## SPMFlex<sup>TM</sup> Software Release 1.0.6

1998-1017 Rev 1 5/18

### Firmware 1.0.6 Update

Technical Note 1998-1017

#### **User Interface (UI) Menu Changes**

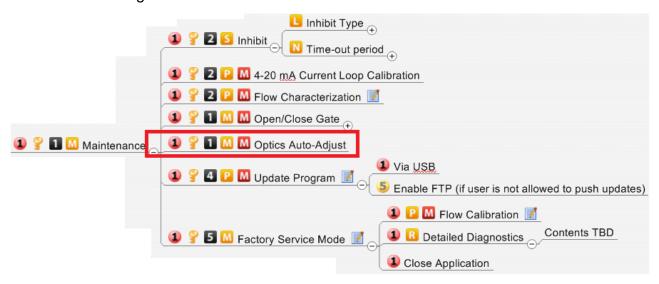
Menu structure of UI application has been modified so a routine maintenance engineer can access optics adjustment functions and check the optics counts.

- Optics auto adjustment menu moved up from Maintenance → Factory Service menu to "Maintenance" menu
- Detailed Diagnostics menu moved from Maintenance → Factory Service menu to "Review" menu
